Office Action Summary	Application No. 10/689,318	Applicant(s) STAMPER ET AL.	
	Examiner Amanda F. Wieker	Art Unit 3743

DETAILED ACTION

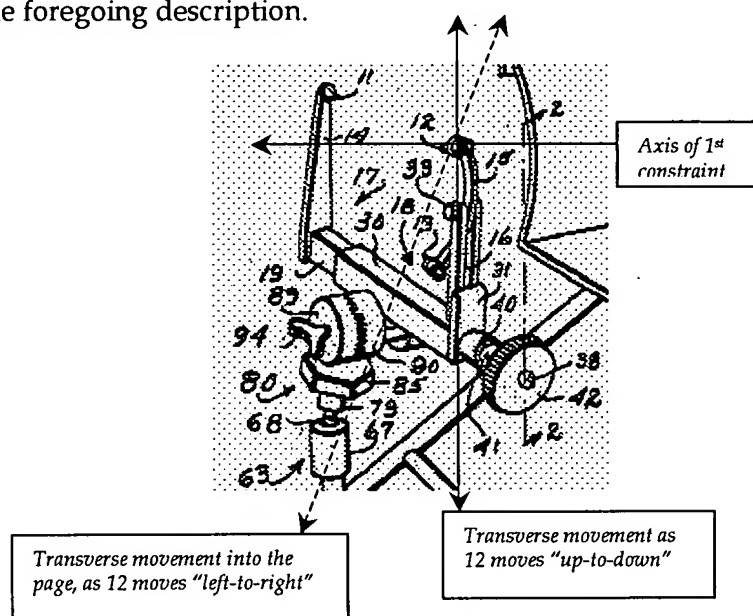
On page 4 of the Remarks, Applicant argues that Ries does not disclose a first constraint configured to permit at least four degrees of motion, wherein the first degree of motion permits motion transverse to the axis of the first constraint.

The examiner disagrees. The first constraint can be considered to be either of constraint 12 or 13, though for this discussion reference number 12 will be considered as the first constraint. The axis of constraint 12 extends left to right in Figure 1. Movement transverse to that axis would extend either into the paper as the constraint moves left-to-right, or up-and-down, with respect to Figure 1. The system disclosed by Ries allows movement of the first constraint along both of these axes, transverse to the axis of 12. As constraint 12 pivots about point 33 the constraint moves both up-and-down (i.e., from the top of the page to the bottom of the page) and left-to-right (into and out of the page). Both of these motions occur transverse to the axis of the constraint itself. Movement "along the axis" of 12, or "parallel to the axis" would

be affected only by movement of the constraint 12 toward constraint 11. Therefore, the examiner disagrees with Applicant's position, and maintains that Ries discloses motion transverse to the axis of the first (12) constraint. The examiner has provided the following marked-up version of Figure 1, to aid in the foregoing description.
